RE: GEOTECHNICAL REVIEW OF MACRAES LOM DESIGN 2015

GEOTECHNICAL REVIEW
MACRAES LOM DESIGN 2015

PSM71-194R

OceanaGold Macraes Mine Geotechnical Review of LOM Design 2015 CORONATION PIT STAGE 3 HIGH RISK AREAS	
PSM71-194R	Figure 12

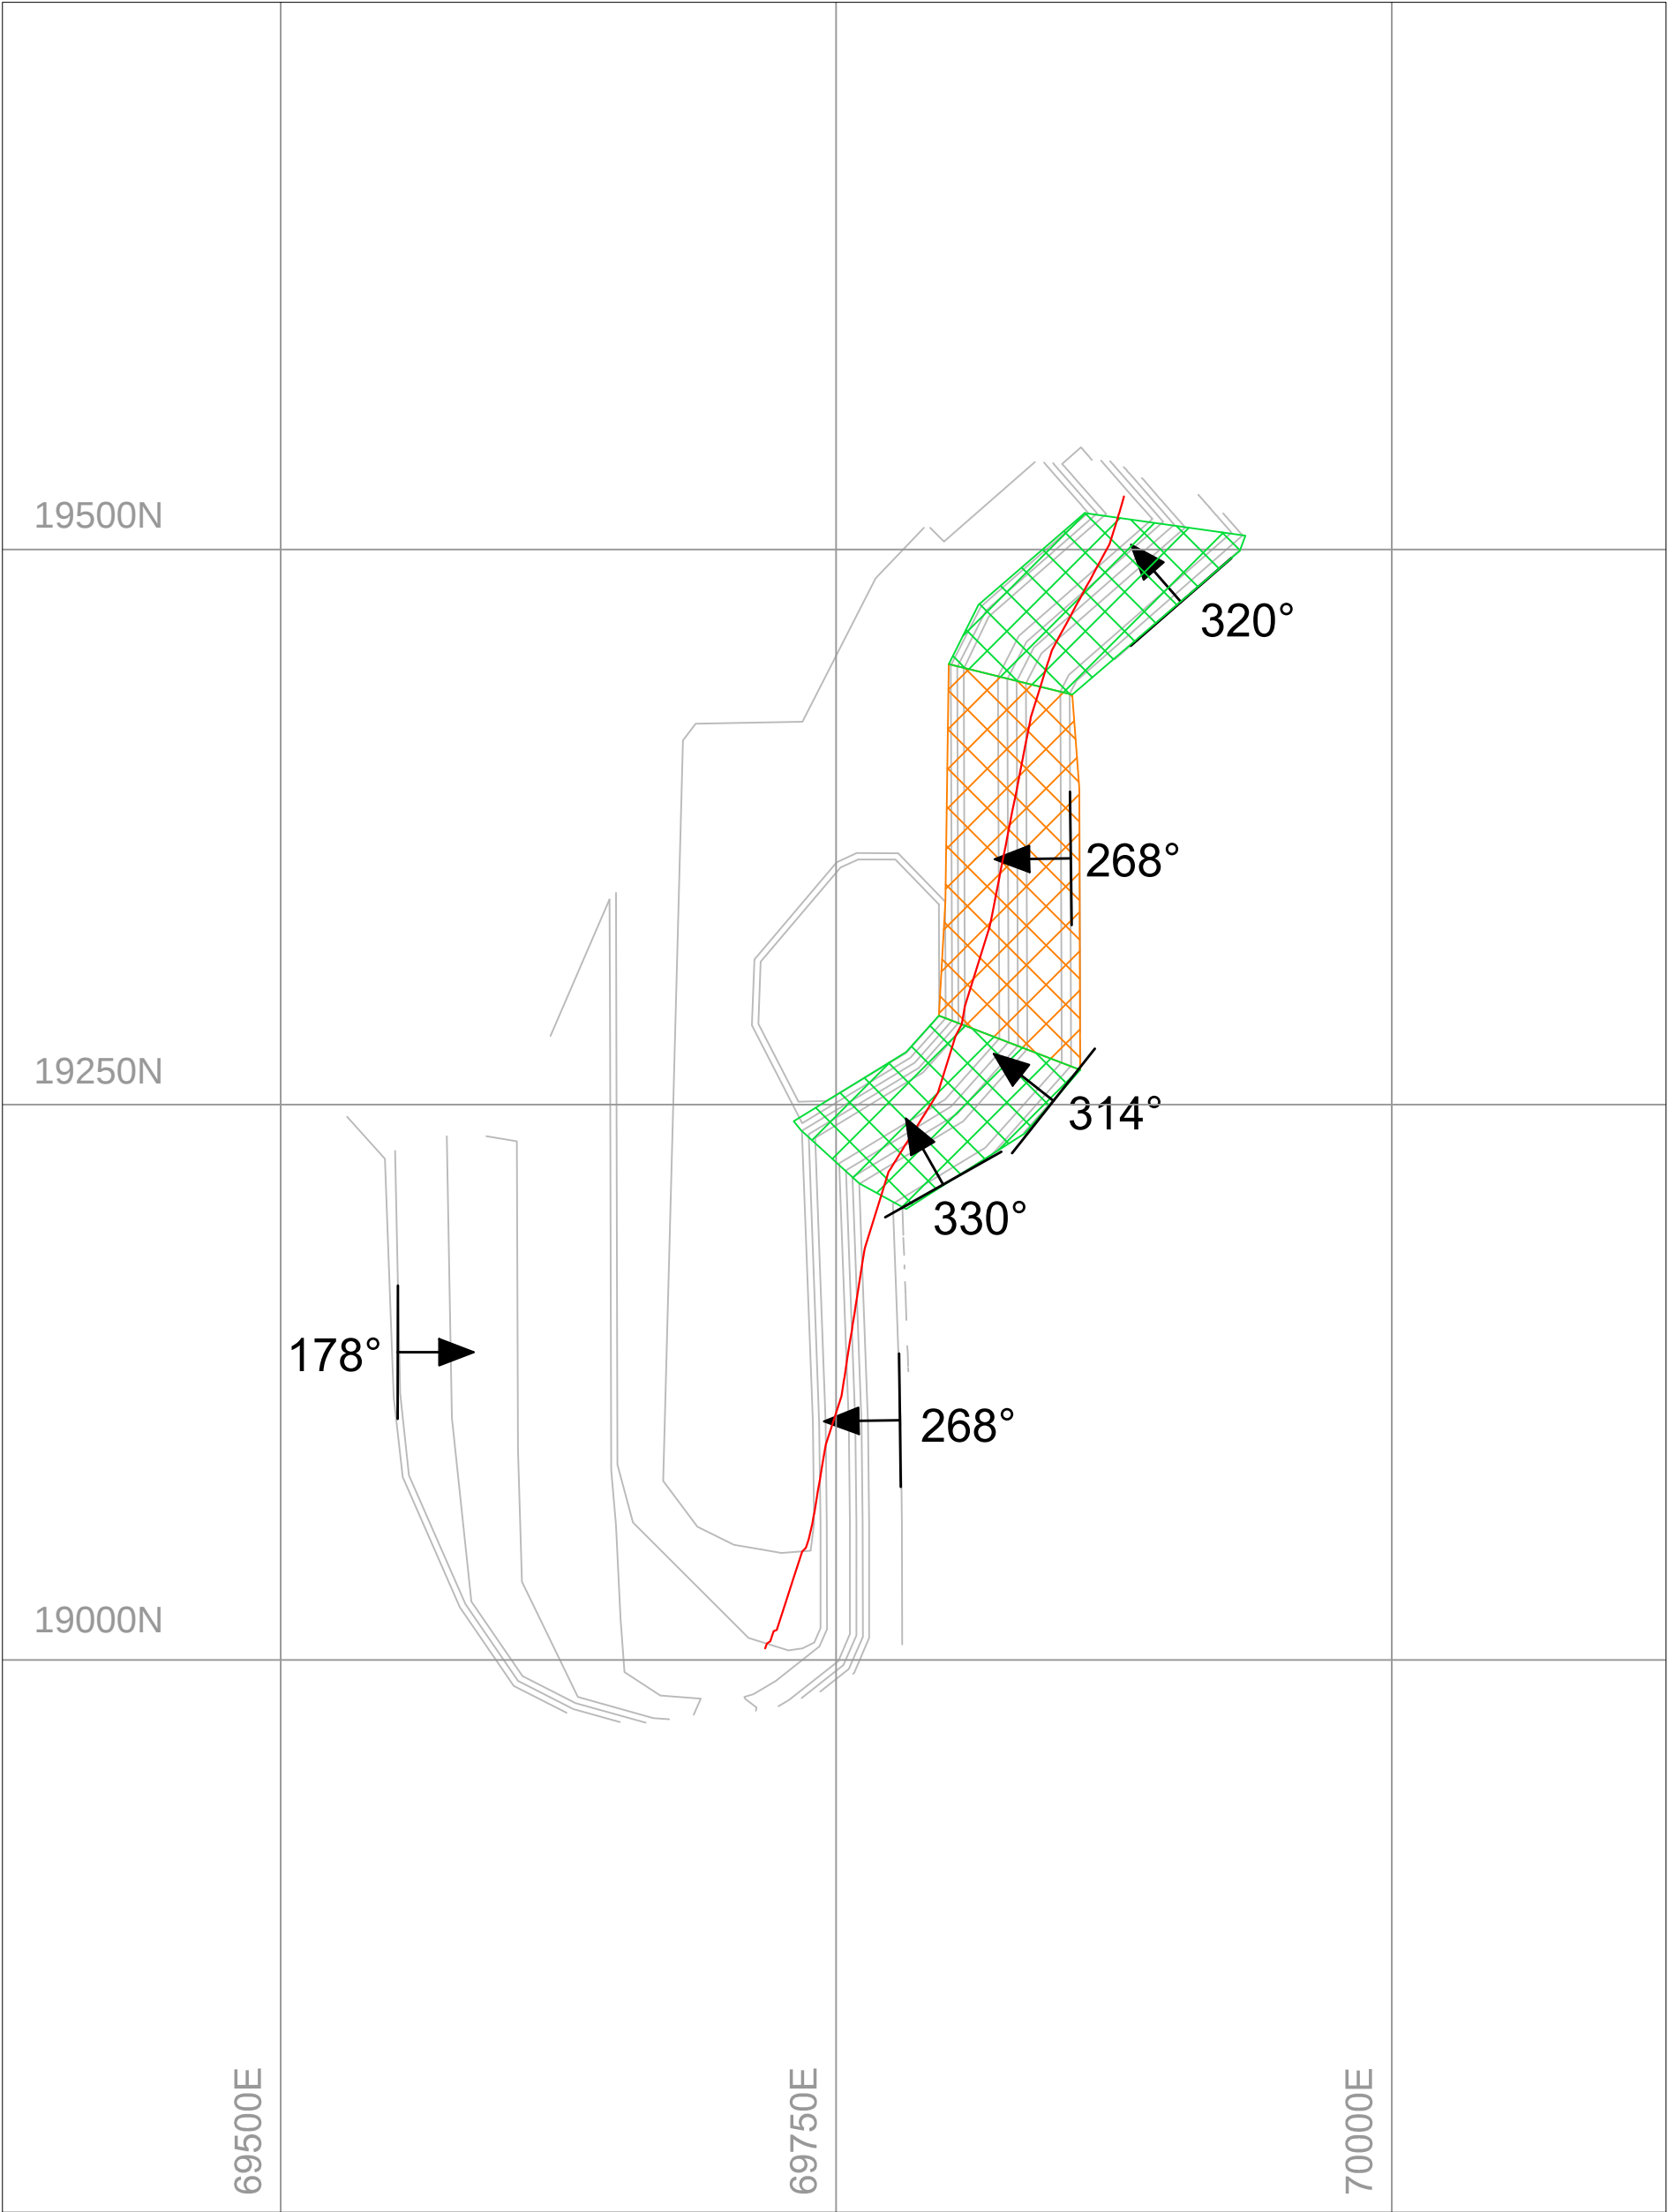
A number of unfavourably oriented slope sectors for Coronation east walls are included in Stages 2 and 3. These slope sectors are at risk of wedge and planar failure from north-south trending moderately west dipping fault and shear structures. They are identified in Appendix B and shown in Figures 11 to 12 as having a high risk of instability.

The impact of the north-south trending faults on the stability of the east wall is known by OceanaGold. It is understood that this risk is being managed by the day-to-day mining operations.

Geotechnical face mapping of east walls is recommended to facilitate the design of future cutbacks and pits.

OceanaGold Macraes Mine Geotechnical Review of LOM Design 2015	
INNES MILLS PIT STAGE 1 SECTION 13720 mN	
PSM71-194R	Figure 14

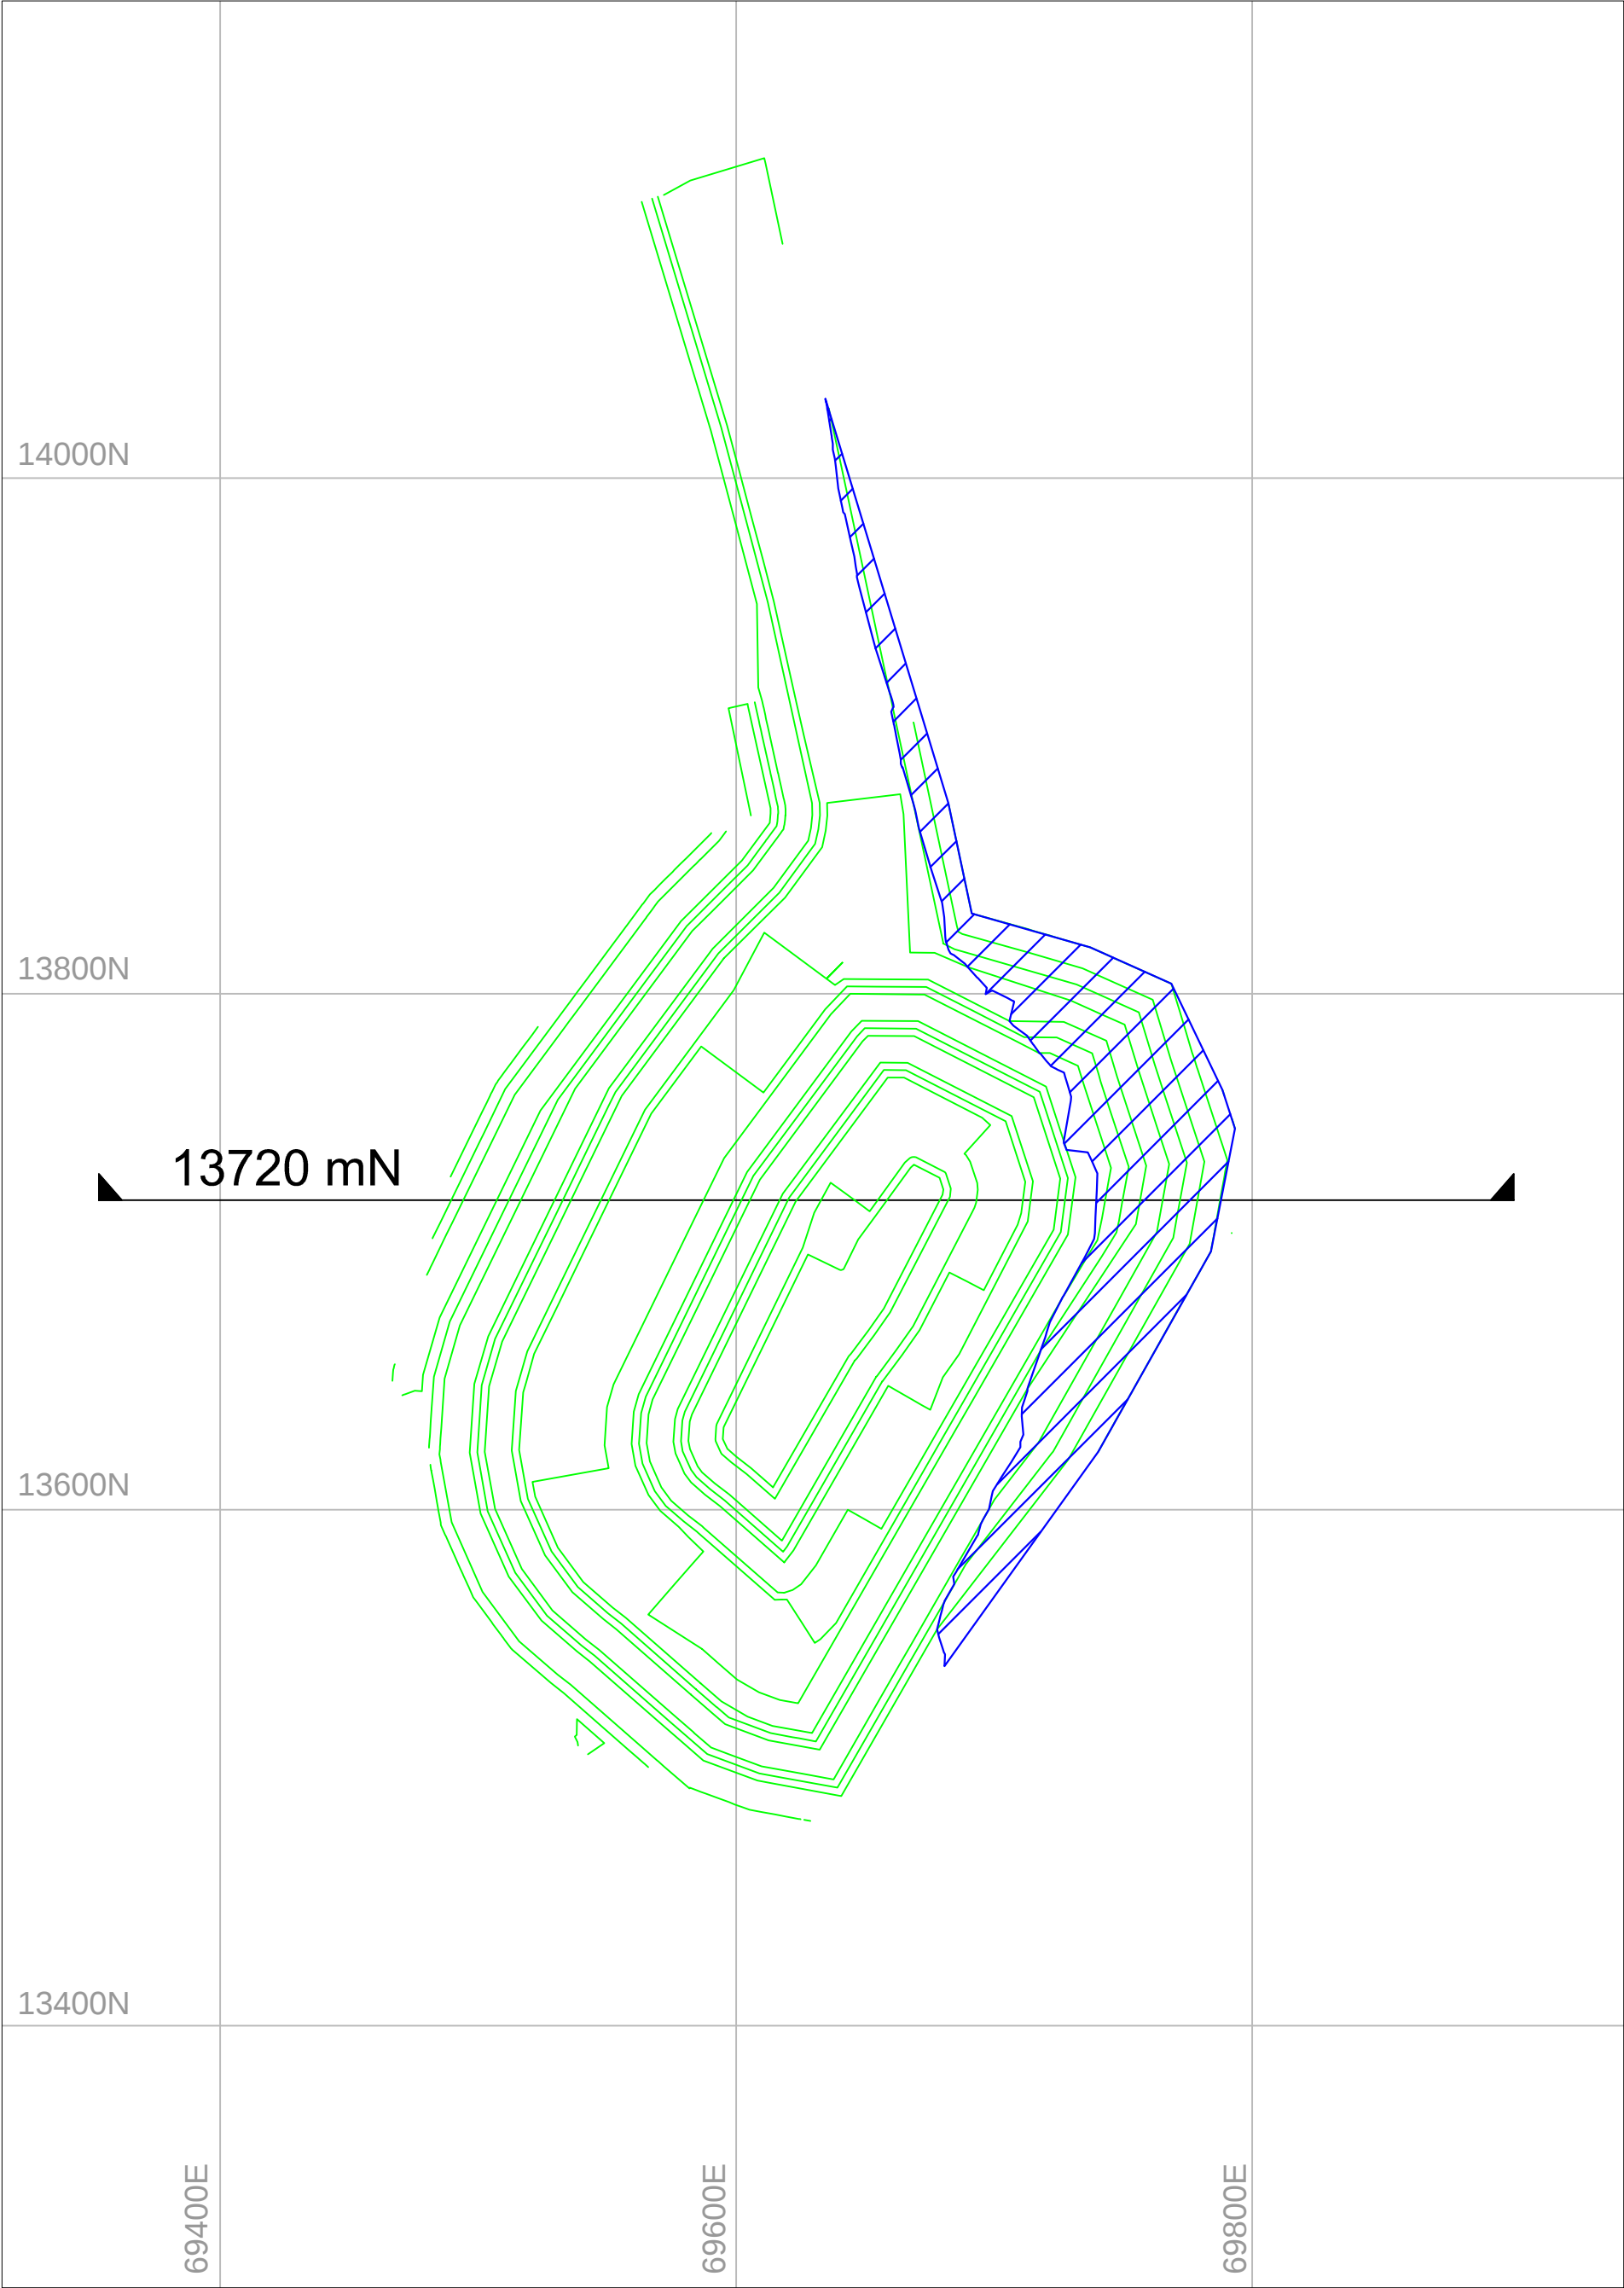
The west wall is off-set more than 50 m from the FF (Figure 14). Therefore, no significant displacement of the west wall along the FF is expected.
